Access Compliance Report Public Rights-of-Way (Pedestrian Signals)

Main Street: **BROOKHURST_ST** Cross Street: **CERRITOS_AVE** Location: **NW**

ADA ID: **SGRK210923104403** Signal Type: **One Push Button-Non APS** Overall Compliance: **No** Severity Scores: **BTN 1: 10** **BTN 2: N/A** **No BTN: N/A**

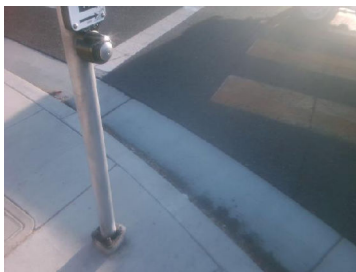
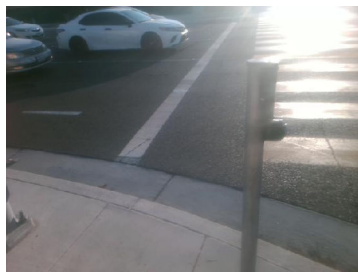
OC Std/PROW: MUTCD 4e.08

Possible Solutions: Replace Signal Push Button With APS Button. Remove & Relocate Sign.
